**Village Plan Commission
Meeting Agenda
Monday, October 10, 2022
5:30 P.M.**

TO: Intergovernmental Agreement (IGA) Joint Commission & Village of Somers Plan Commission
FROM: Luke Godshall, Senior Land Use Planner
RPT DATE: 09-27-22
MTG DATE: 10-10-22
RE: Somers Bobcat

PROJECT:
Somer's Bobcat
 1242 122nd Avenue
 Somers, WI 53171

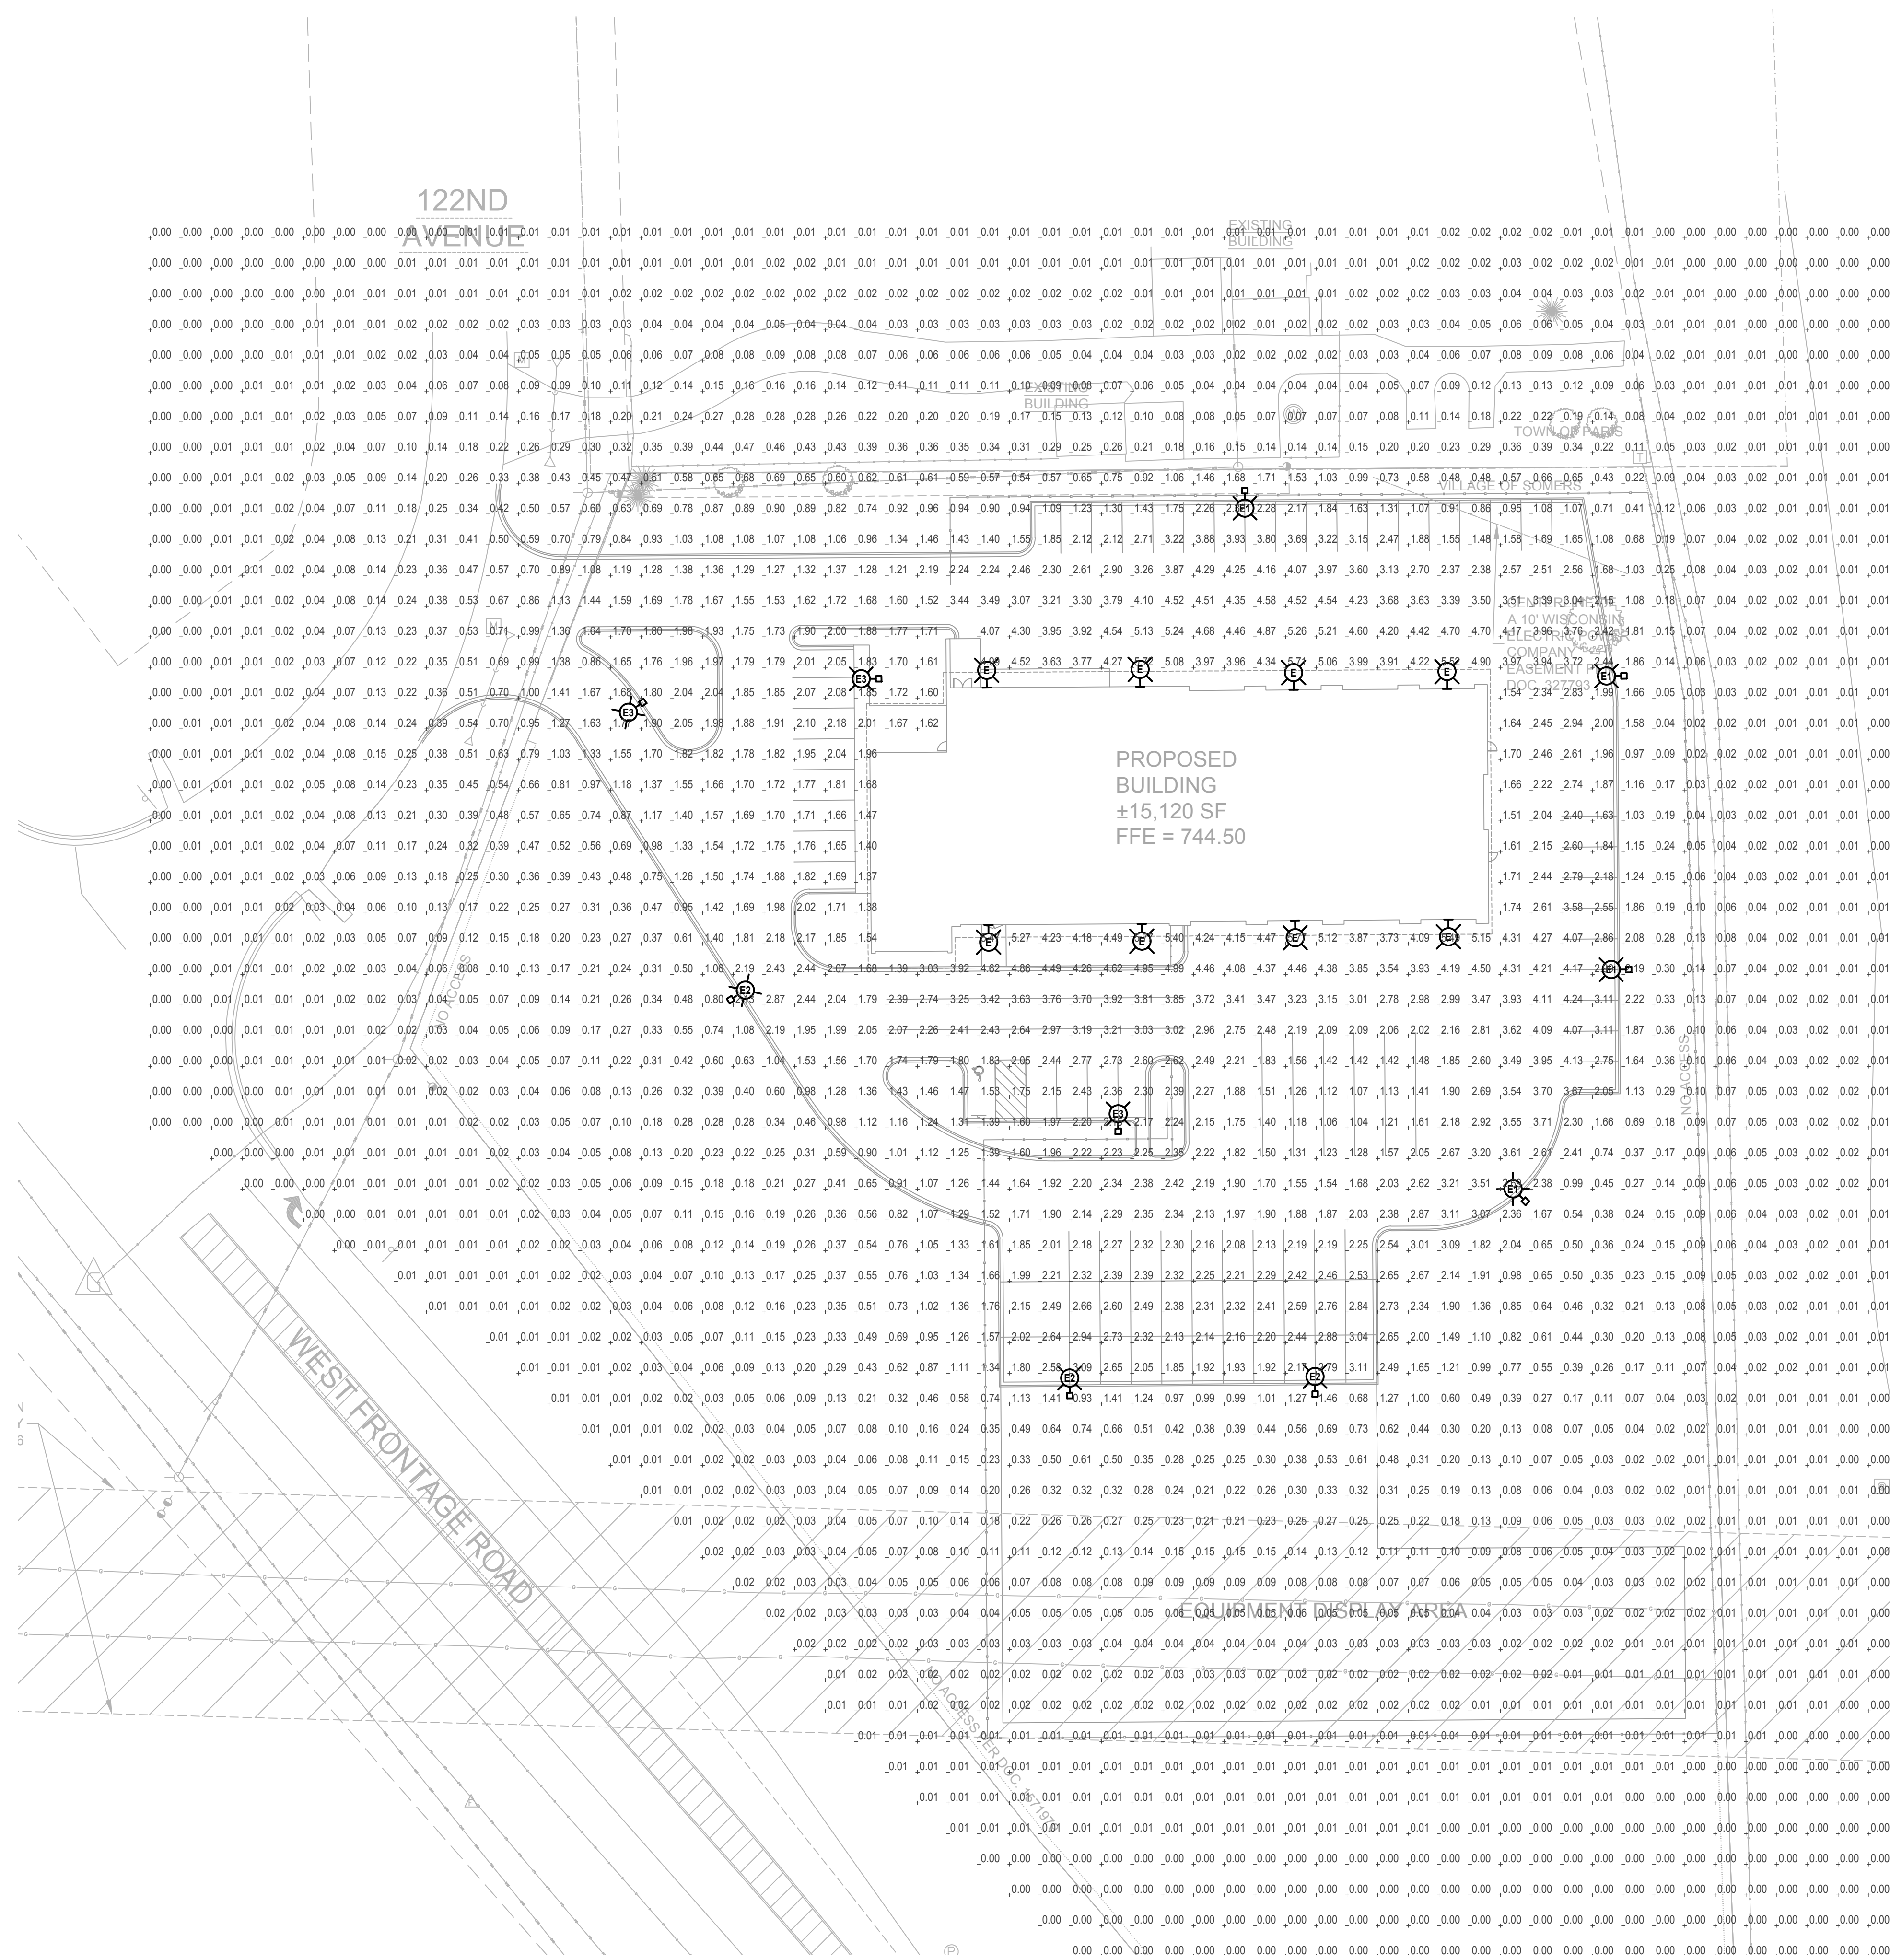
A photometric site plan (dated 08-29-22 by Kornacki and Associated, Inc.) was submitted by the Petitioner and shows compliance with Village of Somers zoning ordinance requirements for light intensity (not to exceed 0.5 footcandles at property lines), fixture height (a maximum of 25' in height is permitted for parking lots serving 20 or fewer parking spaces and up to 30' in height for parking lots with more than 20 spaces), and use of fully-shielded fixtures.
